Refer to: HSA-10/SS-114

Thank you for your July 12, 2002, letter to Mr. Nicholas Artimovich requesting Federal Highway Administration (FHWA) acceptance of your company's NEX Tube as a breakaway component of a crashworthy mailbox support for use on the National Highway System (NHS). Accompanying your letter were photographs of your proposed mailbox mounting systems. You requested that we find the NEX Tube Mailbox Support System acceptable for use on the National Highway System under the provisions of National Cooperative Highway Research Program (NCHRP) Report 350 "Recommended Procedures for the Safety Performance Evaluation of Highway Features." On October 12, 2002, you provided additional information on a redesigned support for accommodating multiple mailboxes.

SQUARE		MUTI. MAIL BOX SUPPORT	
TUBE PRODUCTS			
COMMERCE CITY, CO.		SIZE	FSOM NO.
		1-888-267-6463	DWG NO. 1
		SCALE 1:1	REV A
		SHEET

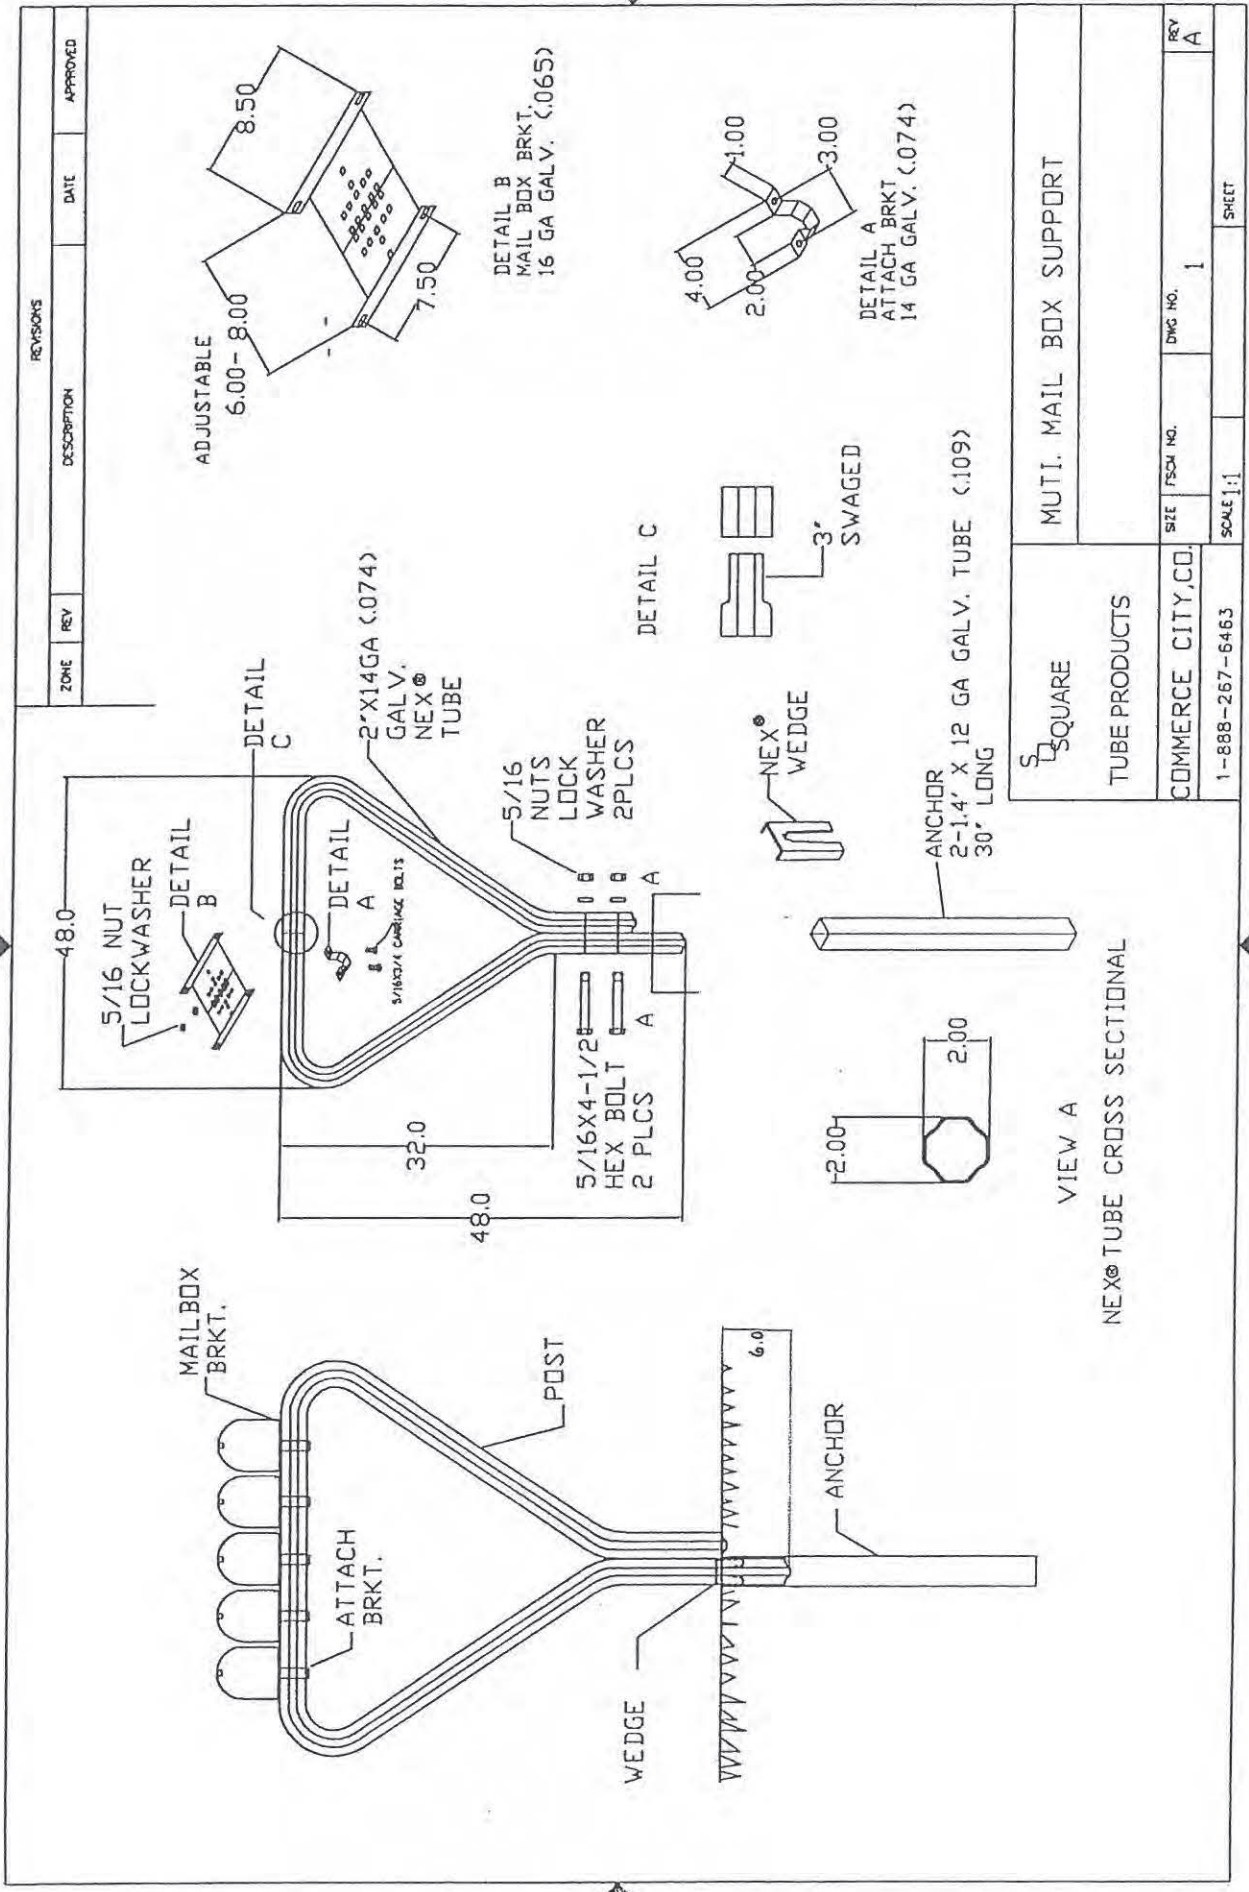
You also asked that we accept the NEX tube for use with multiple mailboxes using the "inverted coat hanger" arrangement. When the V-Loc system was tested with a multiple mailbox support (using 14 gage steel pipe in an "inverted coat hanger" arrangement) the occupant impact speeds were almost at the limit of acceptability. Because your design did not replicate the basic "closed loop" shape of the V-loc system, we were not as certain that five-box support using the NEX tube would meet the occupant impact velocity requirements. You have since redesigned your multiple mailbox support to replicate the "inverted coat hanger" arrangement, which we expect will perform in an acceptable manner.

The single/double mailbox support and the "inverted coat hanger" multiple mailbox support described above and shown in the enclosed drawings for reference are acceptable for use as Test Level 3 devices on the NHS under the range of conditions tested, when proposed by a State. The single box supports are considered crashworthy for conventional rural mailboxes weighing up to 5 pounds. The multiple box supports are considered crashworthy when boxes weighing up to 3.5 pounds each, are used.

S ² SQUARE TUBE PRODUCTS		SINGLE MAIL BOX SUPPORT	
SIZE	FSCM NO.	DWG NO.	REV
COMMERCE CITY, CO		1	A
1-888-267-6463		SCALE	SHEET

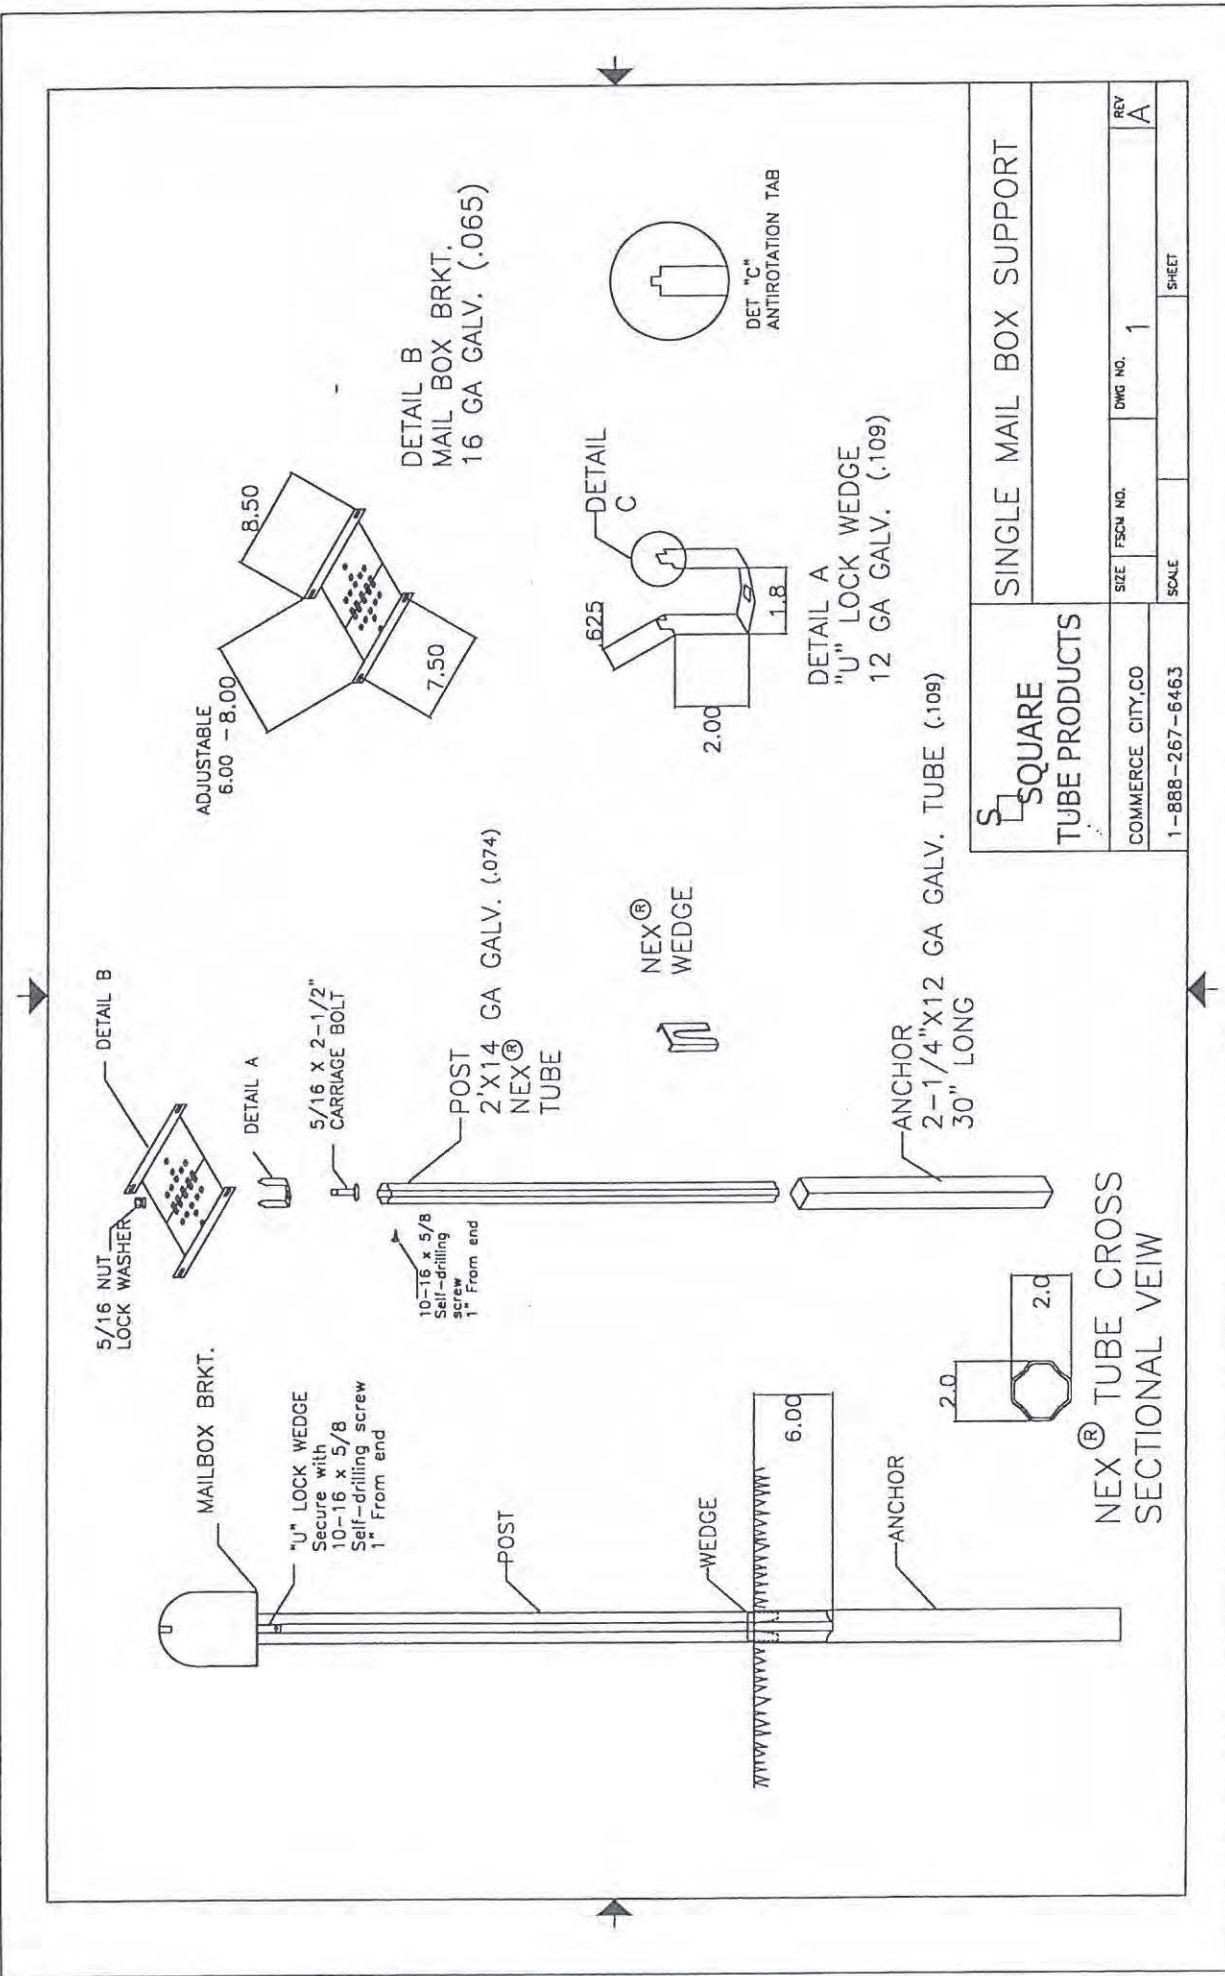
dual post support. You asked that we compare your socket design to the V-Loc system, which has already been tested as a mailbox support. We concur with your assertion that the same technology will be effective as a single/double mailbox support. Therefore, the NEX Tube sign support will be acceptable for use as a single/double mailbox support using the socket and wedge design as shown in the enclosed drawings.
